Arts Building Seismic Correction & Renewal
Project No. FM090010L/988720

Addendum No. 3

July 14, 2010

ADDENDUM NUMBER 3

A7.11

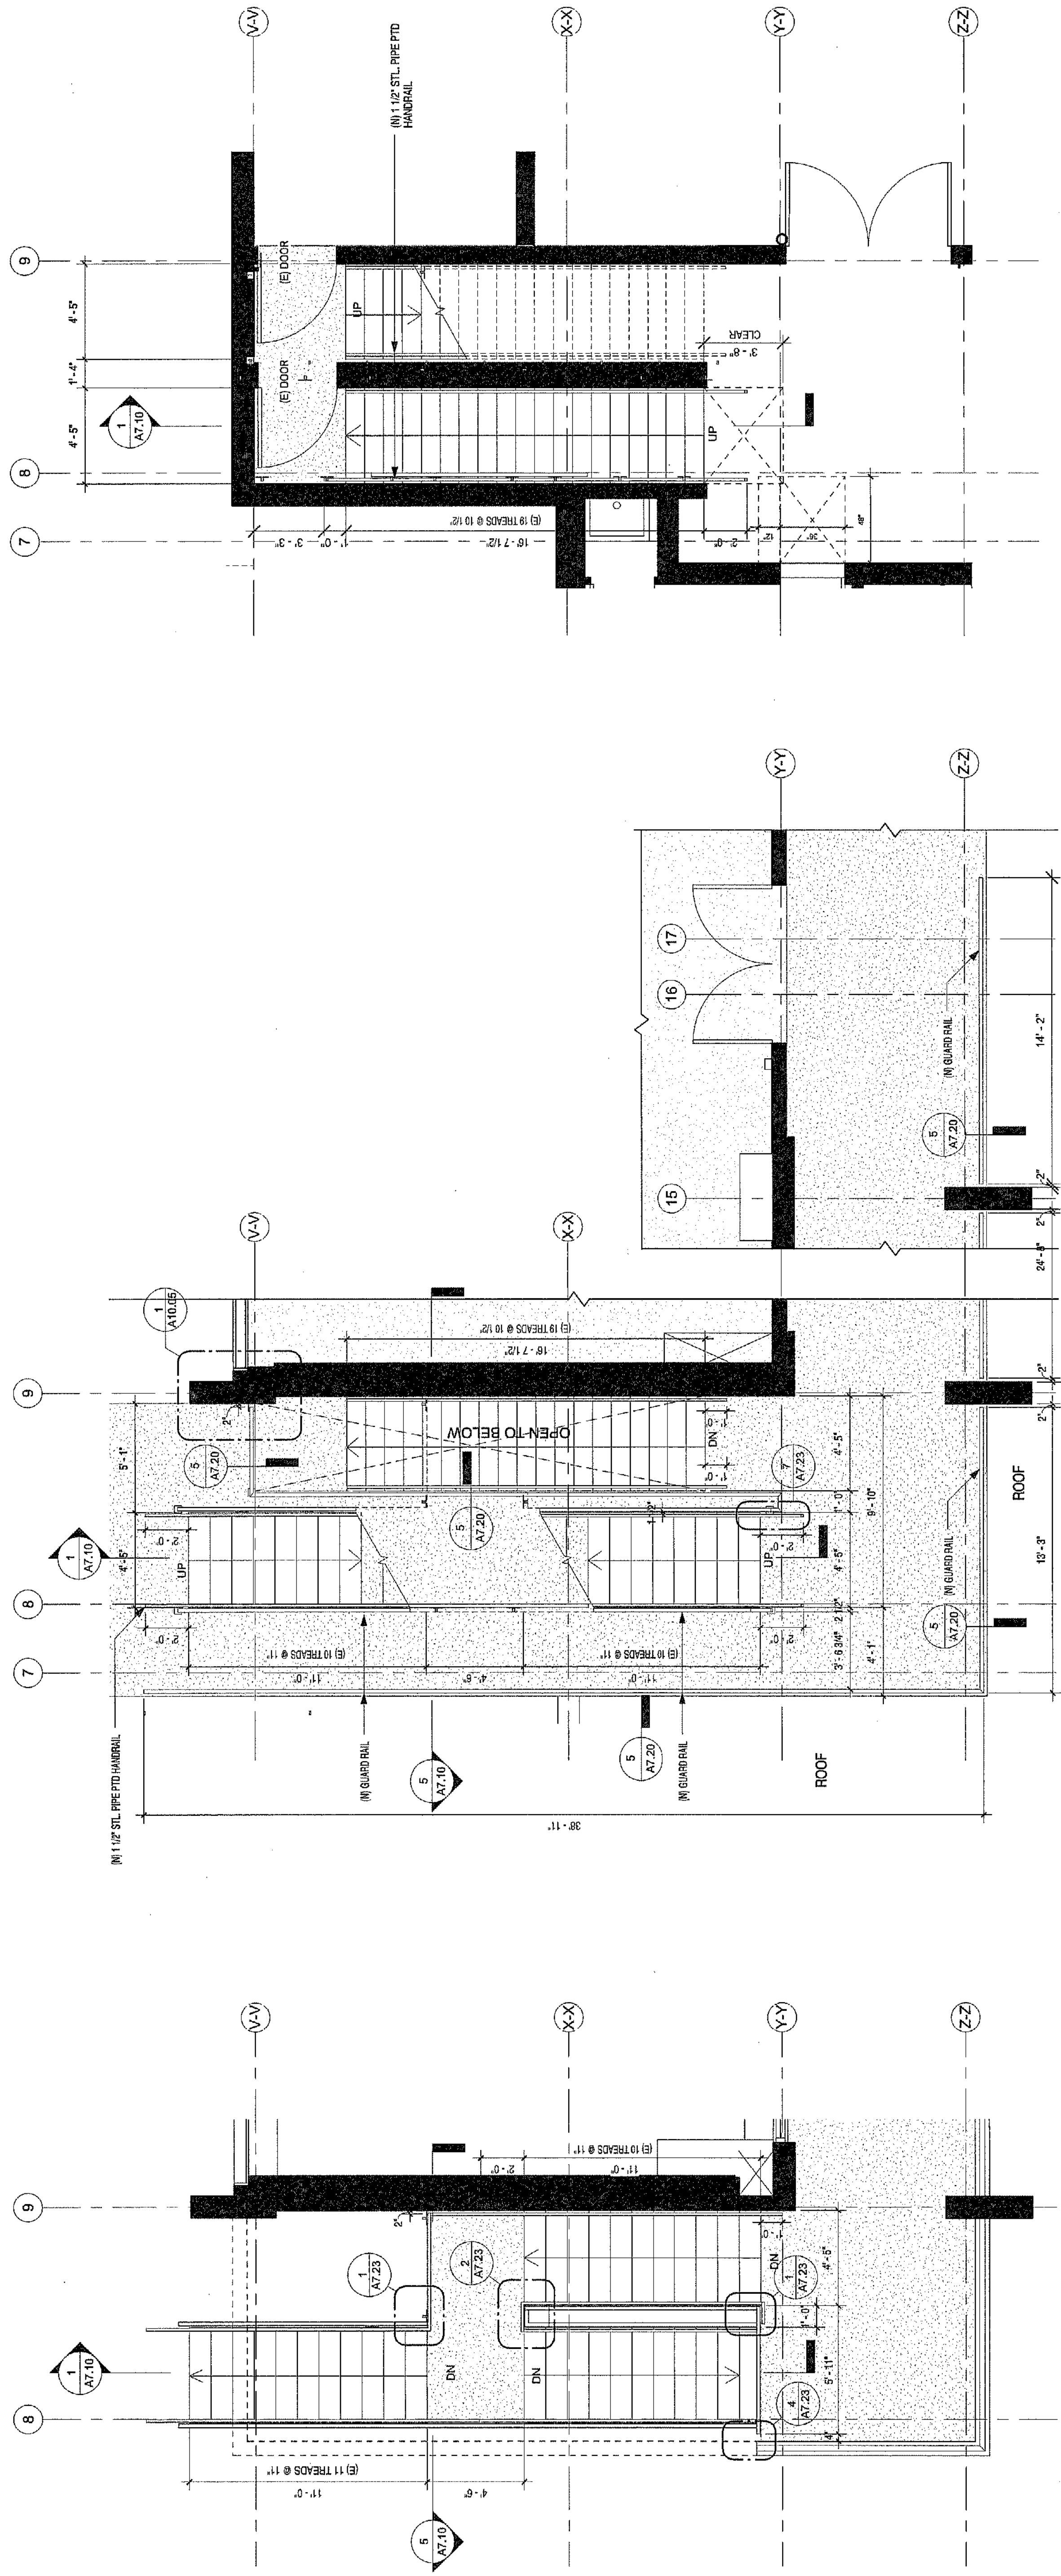
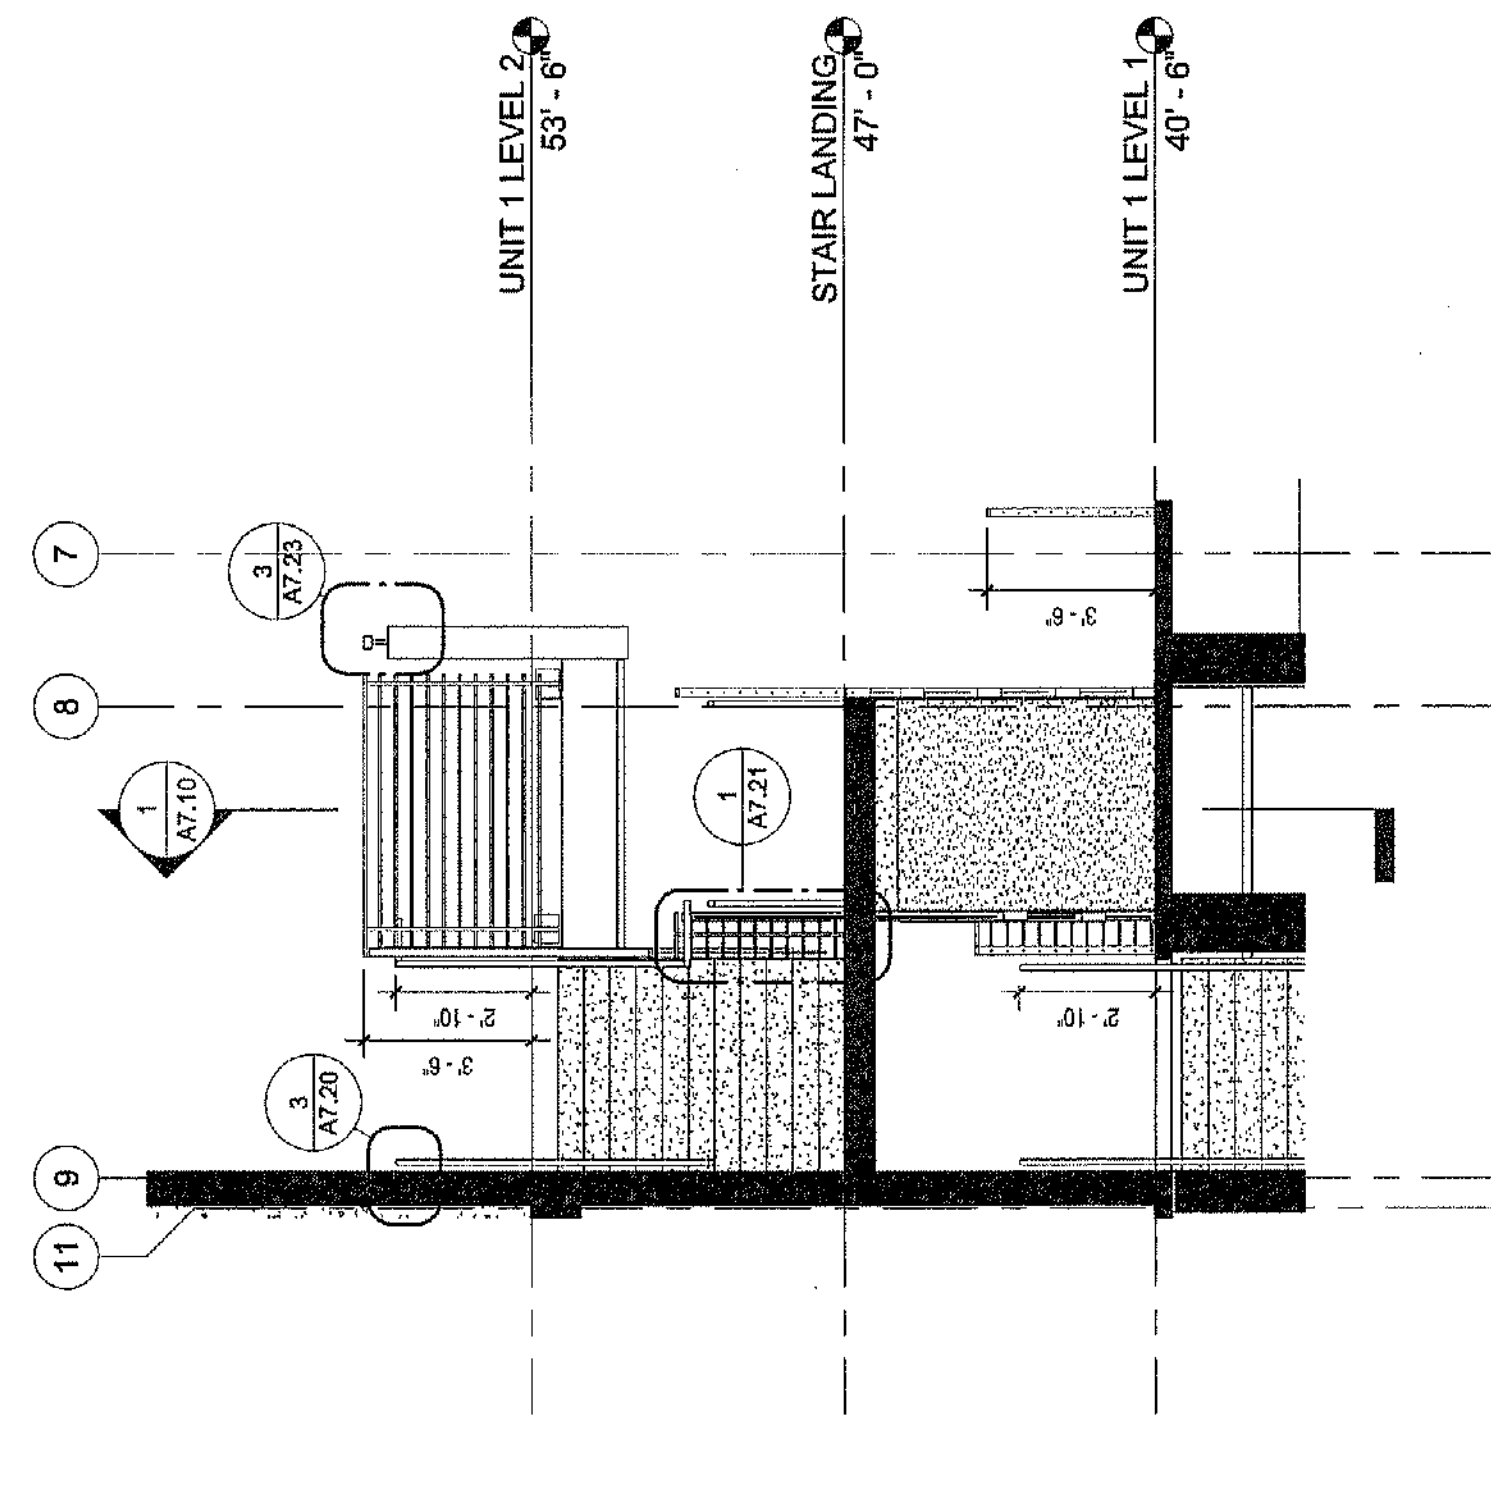
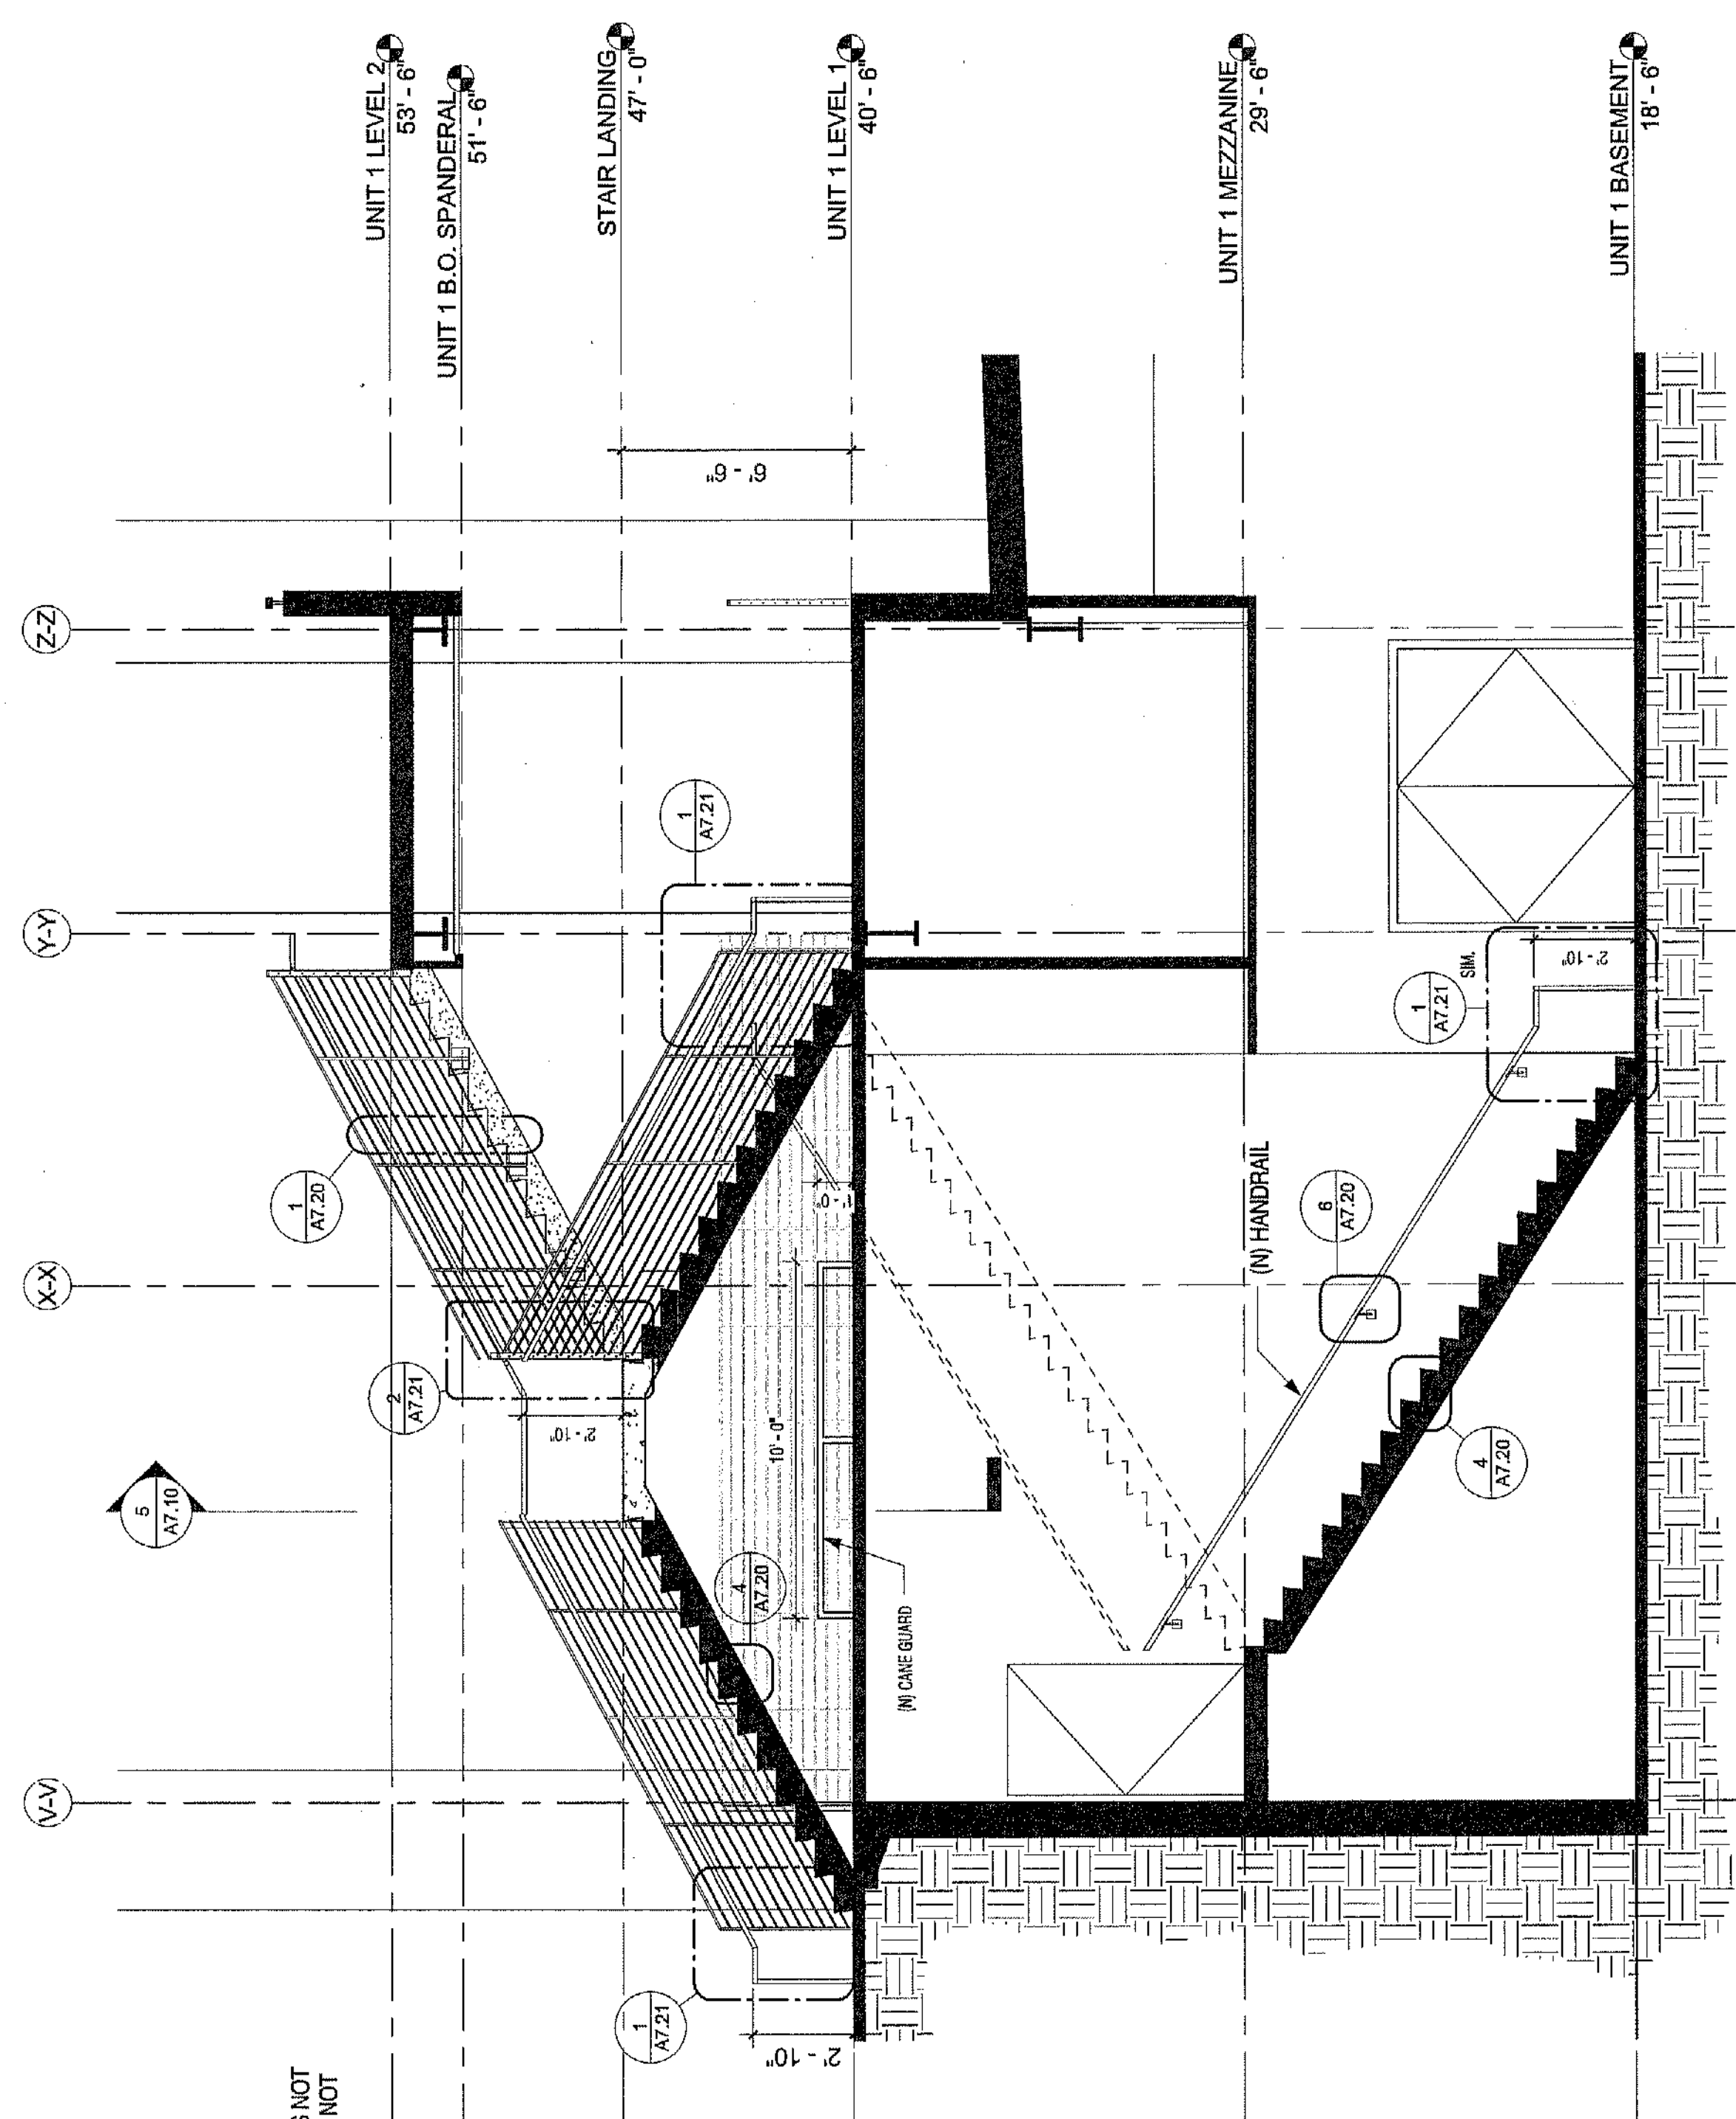
15. DRAWING NO. A7.11, STAIR NO. 2 , Replace in its entirety with attached drawing A6.12, dated 7/8/2010.
